Work Order ID 105234

Item Name: Crosstube Turning Detail

<b>DART AEROSPACE LTD</b>	<b>Work Order:</b>	10523 Y
<b>Description:</b> Crosstube Assembly (412 High Aft)	<b>Part Number:</b>	D412-664-243
<b>Inspection Dwg:</b> D412-664-243 <b>Rev:</b> E		<b>Page 1 of 2</b>

DRAWING NO. D412-664-243	TITLE CROSSTUBE ASSEMBLY (412 HI AFT)	REV. E	DART AEROSPACE LTD ENGINEERING ORDER		D.E.O. NO. D412-664-243-E-4	SHEET NO. SHEET 1 OF 3	SCALE NTS
DRAWN 90	CHECKED A	MFG. APPR. A	APPROVED MP		DE APPR. MP		
DATE 12.08.21	DATE 12.08.30	DATE 12.08.30	DATE 12/8/30		DATE 12.08.30

### WALL THICKNESS MEASUREMENT

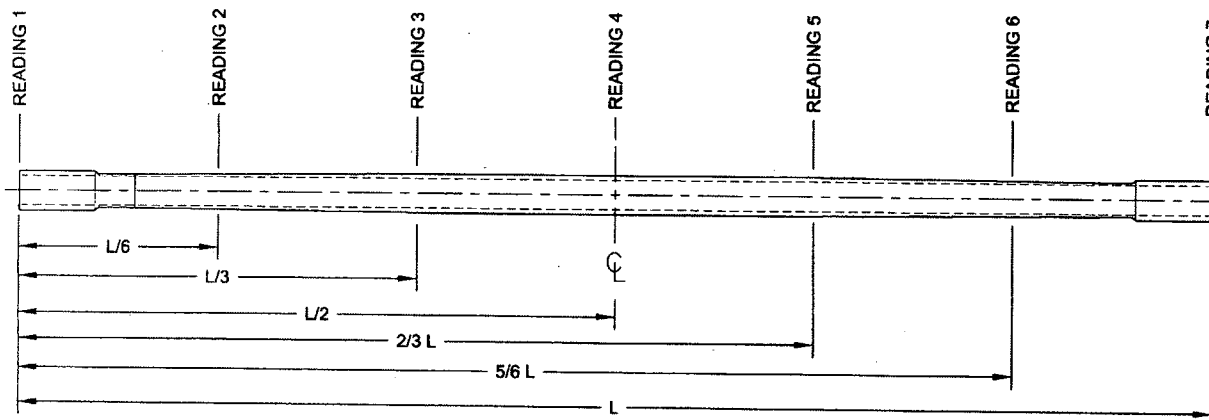
Root Cause		Date	Step	Qty	Description of work order update or Non-conformance	Initial Chief Eng	Action Description	Sign & Date	Verification	QC Inspector
Doc/Data		13/8/22	100	1	ultrasonic wall measurement is over tolerance.	CP 13/8/22	Acceptable. Min wall is 0.022 under nominal. 126009 allows $\pm 0.063$	CP 13/8/22	TW 13-08-28	68-6 91 DAS  13/09/10
Equip/Tooling										
Operator										
Material										
Setup										
Other										
Process										
Supplier										
Training										
Unapproved

**D412-664-243  
ASSEMBLY DETAIL**

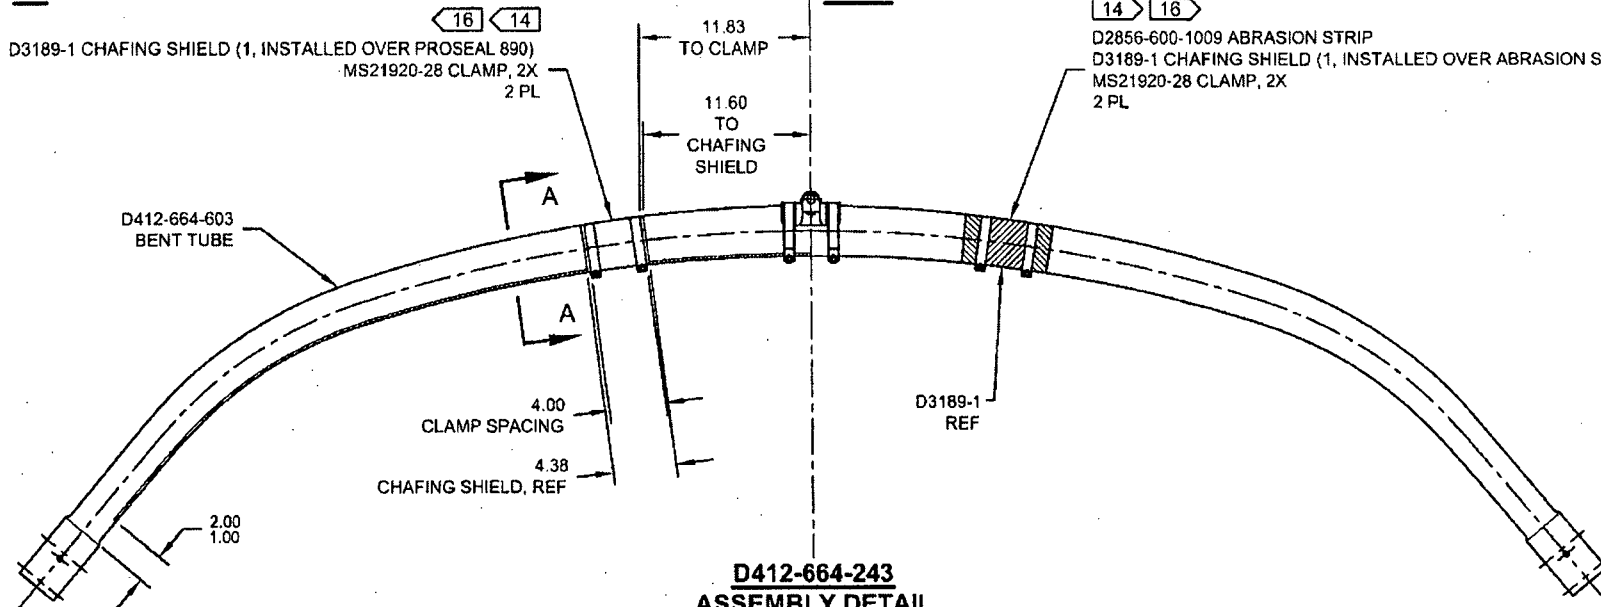
REMOVED ABRASION STRIP IN FAVOR OF A THIN LAYER OF PROSEAL 890. UPDATE INSTALLATION OF CHAFING SHIELDS AND REDUCE TORQUE TO 40-50 IN-LBS. THIS ENGINEERING ORDER SUPERCEDES DEO D412-664-243-E-1.

**IS:**

D3189-1 CHAFING SHIELD (1, INSTALLED OVER PROSEAL 890)  
MS21920-28 CLAMP, 2X  
2 PL

**WAS:**

D2856-600-1009 ABRASION STRIP  
D3189-1 CHAFING SHIELD (1, INSTALLED OVER ABRASION STRIP)  
MS21920-28 CLAMP, 2X  
2 PL
